CONNECTICUT SITING COUNCIL

RE: **EM-SPRINT-013-180509** – Sprint Spectrum Realty Company, LP notice of intent to modify an existing telecommunications facility located at 3 Polly Lane, Bozrah, Connecticut.

The Connecticut Siting Council (Council) received a notice of intent to modify the above-referenced facility on May 9, 2018. On June 25, 2018, the Council issued a letter stating that your request for exempt modification was incomplete and recommended that Cherundolo Consulting provide an updated Structural Analysis (SA) Report accounting for the antenna mount modifications for the proposed equipment that is stamped and signed by a professional engineer duly licensed in the State of Connecticut and updated Construction Drawings referencing the most current SA Report and Antenna Mount Modification. On August 23, 2018 the Council received the requested construction drawings, SA Report and Mount Analysis. However, staff has identified an additional deficiency in the response to the June 25, 2018 notice of incompleteness.

The updated construction drawing sheet numbers ANT-005.00 and ANT-006.00 under structural
note references a structural analysis (SA) report prepared by Maser Con

SHEET TITLE: **EQUIPMENT PLAN AND ELEVATION**
 SHEET NUMBER: **ANT-005.00**

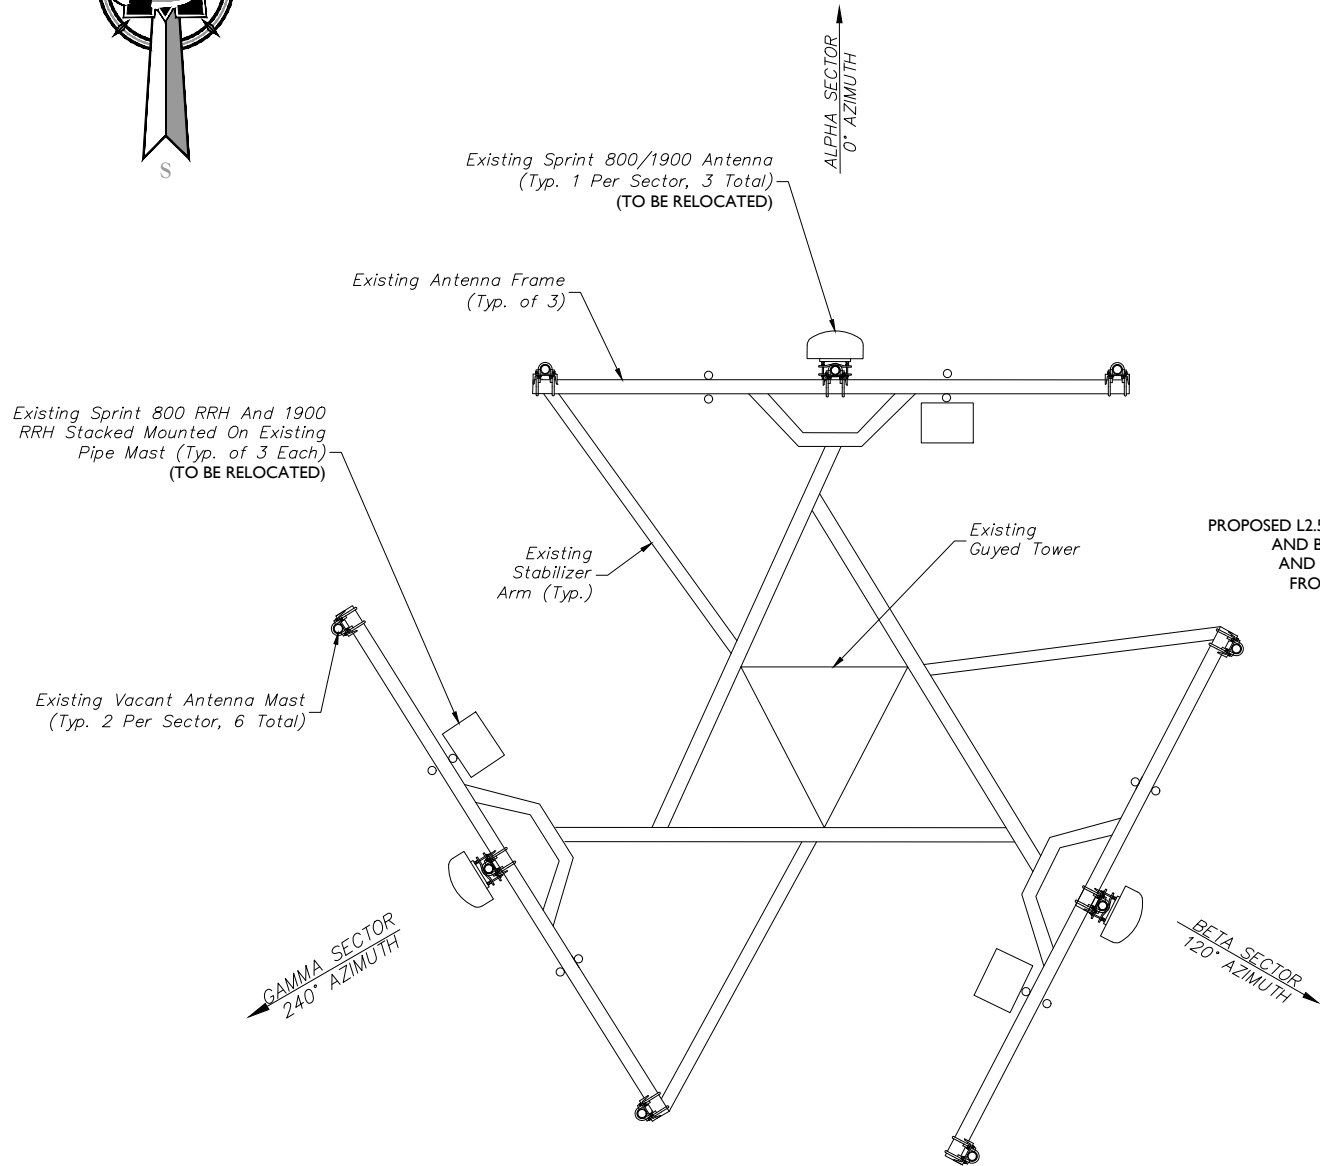
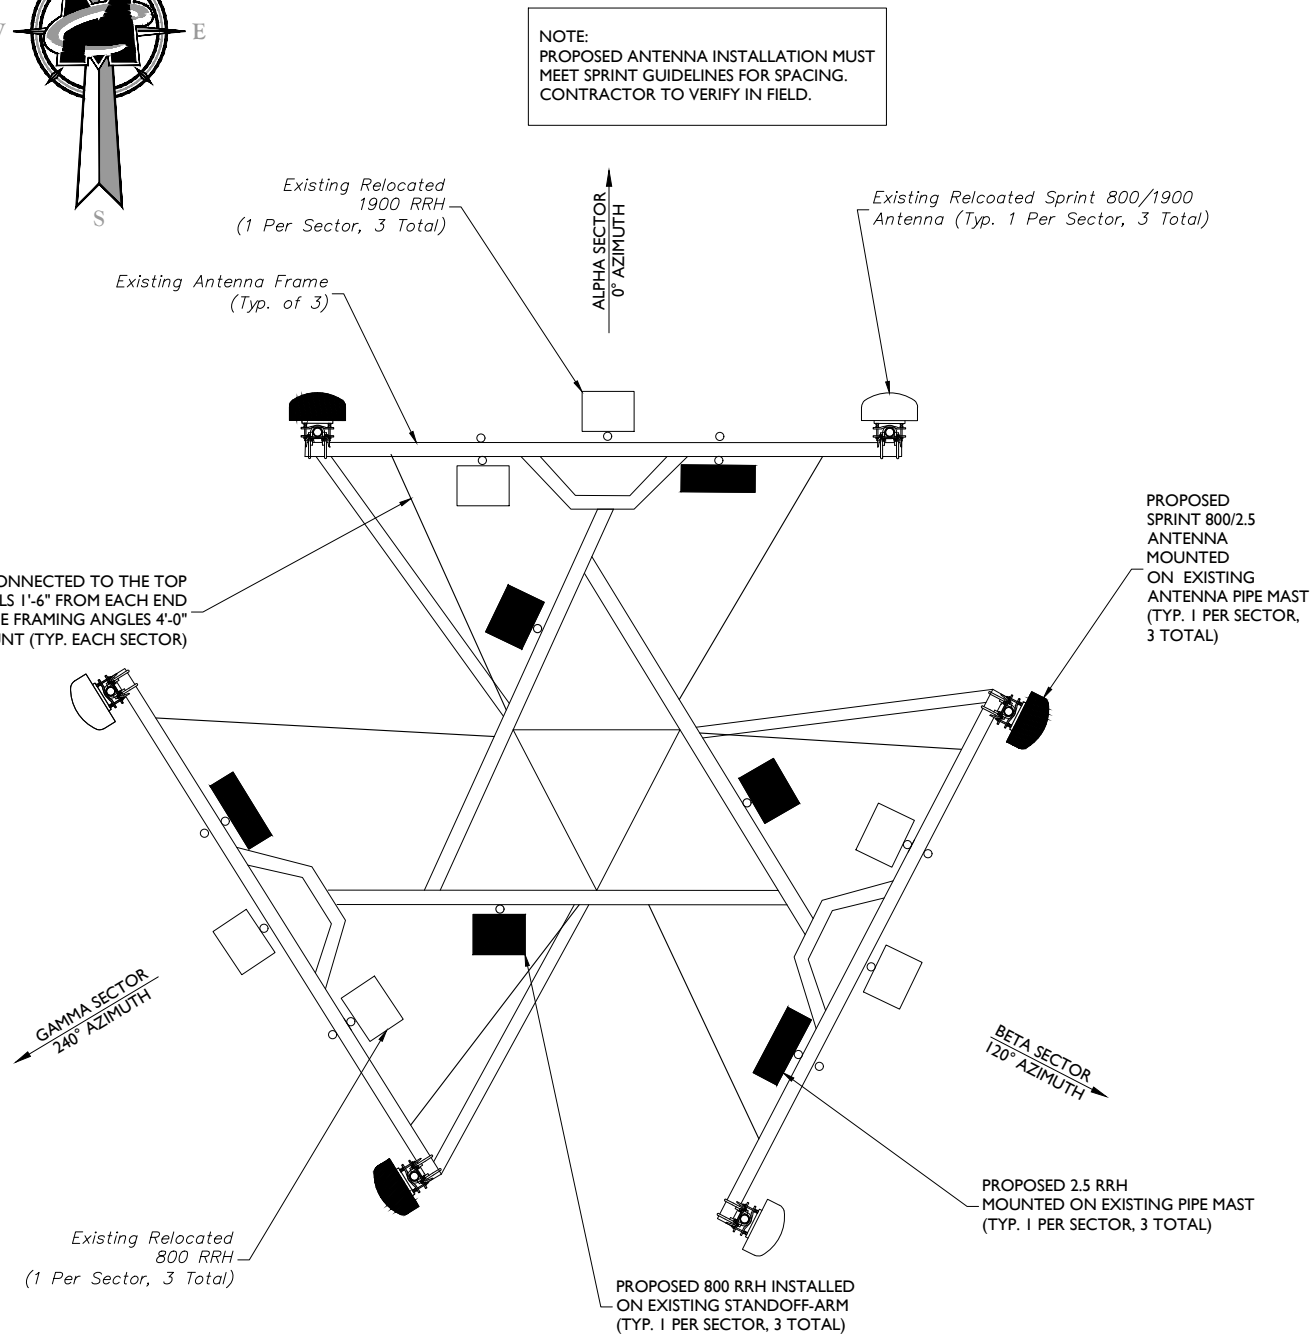
The Construction Drawings submitted in the response refer to a SA Report dated September 17, 2017. However, the SA Report submitted in the response is dated July 24, 2018.

Staff has reviewed this exempt modification request for completeness and has identified a deficiency in the filing. The construction drawings sheet numbers ANT-005.00 and ANT-006.00 prepared by Maser Consulting Connecticut, last revised on September 27, 2017, under Note states "Contractor must verify a passing structural analysis has been completed for Sprint's antenna mounts and the existing tower prior to construction." No mount analysis is included with the exempt modification filing; therefore, it is unclear whether additional reinforcements would be required for the antenna mount, which would alter the proposed loading on the structure and require an updated structural analysis report.

A STRUCTURAL ANALYSIS REPORT PREPARED BY MASER CONSULTING P.A., DATED 07/24/18 AND A MOUNT MODIFICATION REPORT PREPARED BY MASER CONSULTING P.A., DATED 06/19/18 HAVE BEEN PREPARED TO CHECK THE STRUCTURAL CAPACITY OF THE TOWER AND ANTENNA MOUNT TO SUPPORT THE PROPOSED ANTENNA AND EQUIPMENT CONFIGURATION AS DEPICTED WITHIN THESE CONSTRUCTION DRAWINGS. BASED ON THE CONCLUSIONS OF THIS REPORT, THE TOWER AND ANTENNA MOUNT HAVE BEEN DETERMINED TO HAVE SUFFICIENT CAPACITY.
